To: T10 Technical Committee
From: Rob Elliott, HP (elliott@hp.com)
Date: 4 March 2005
Subject: 05-107r0 SAS-1.1 SAM-4 Overlapped tag handling

Overview

Figure 1 — ST_T (transport layer for SSP target ports) state machines

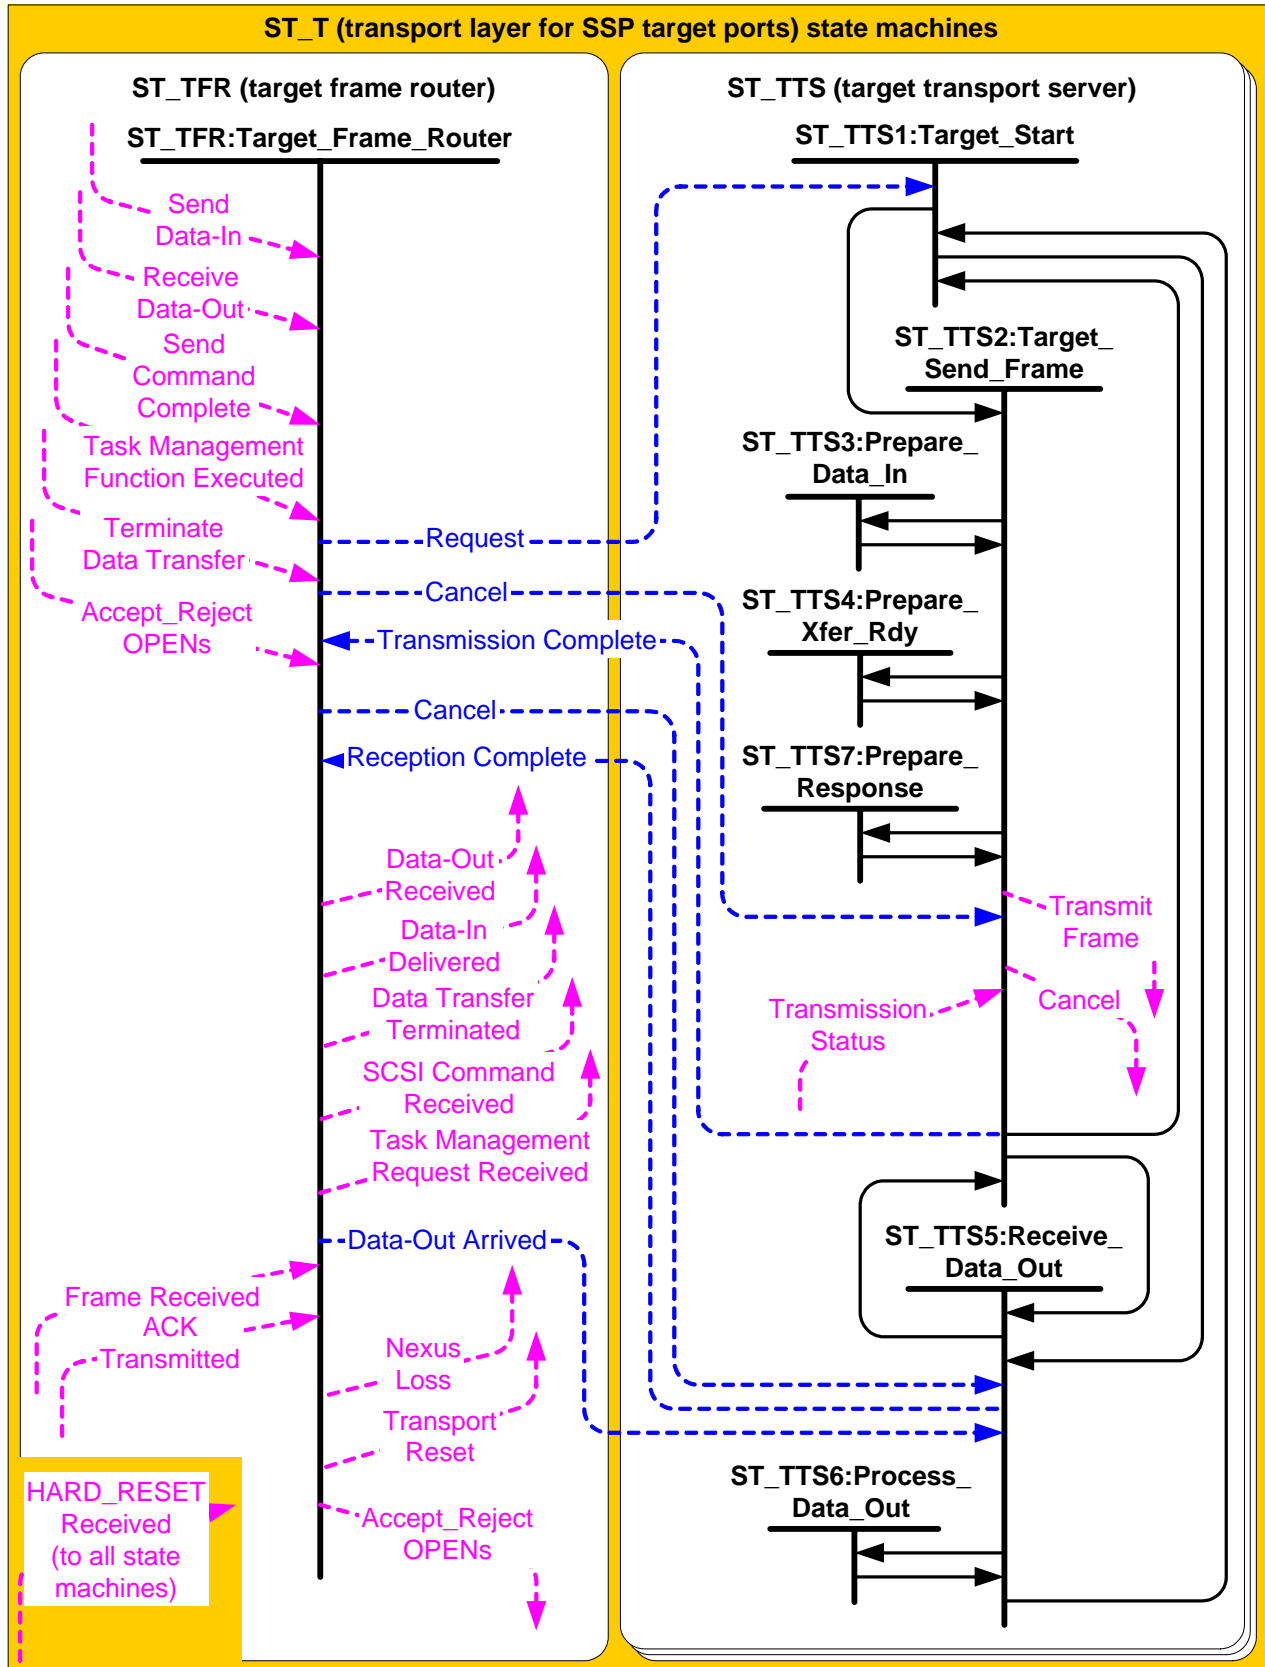
If the frame type is ~~COMMAND~~ or ~~TASK~~, then this state machine may check if the tag conflicts with an existing tag (i.e., an existing command or task management function). If this state machine checks the tag, then this state machine shall, based on the condition, take the action specified in table 4:

Editor's Note 3: ST_TFR simply sends up SCSI Command Received or Task Management Request Received and lets the application determine if there is a tag conflict and return a RESPONSE frame indicating the problem (and do whatever else is required). Send (Request Transport Response) will not imply a RESPONSE frame carrying RESPONSE_DATA type only requested by the transport layer; it can also be requested by the application layer. This helps the overlap case and also is needed for normal TMF completion, which was not supported.

If this state machine receives a Task Management Function Executed transport protocol service response from the SCSI application layer, then this state machine shall send a Request (Send ~~Application~~Transport Response) message to the ST_TTS state machine specified by the tag with the arguments described in table 5, with the following arguments to the ST_TTS1:Target_Start state in an ST_TTS state machine that does not have an active task:

Editor’s Note 4: A TMF doesn’t return status/sense data like a command; it returns a service response indicated by the response code value. The previous paragraph was severely broken, discussing status/sense data and not describing how the response codes are sent.
